Mercedes C-class (203) arms reengineered

Sidem Nr	OE Number
Mercedes	49976	204 330 43 11
Track Control Arm	49977	204 330 44 11
	49978	204 330 19 11
	49979	204 330 20 11

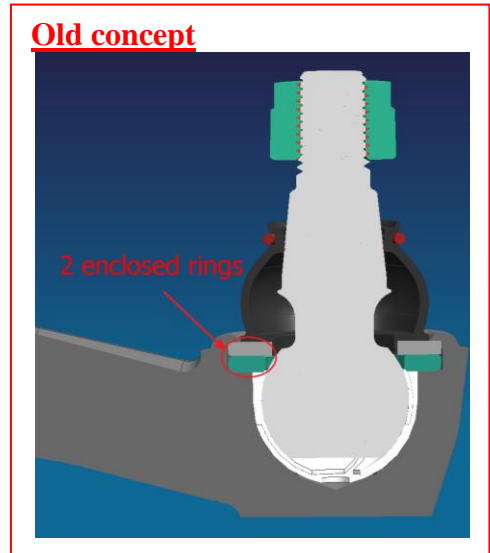
Problem:

- Premature play on ball-joint.

Cause:

- Due to the 2 enclosed rings that close the assembly, tolerances cannot be kept as small,
- this can cause instability-play in extreme conditions.

Solution:

- Classic design with only 1 enclosed ring where the DC is attached on a classical way
- So the closing ring is in direct contact with the insert what offers a more stable-rigid assembly.
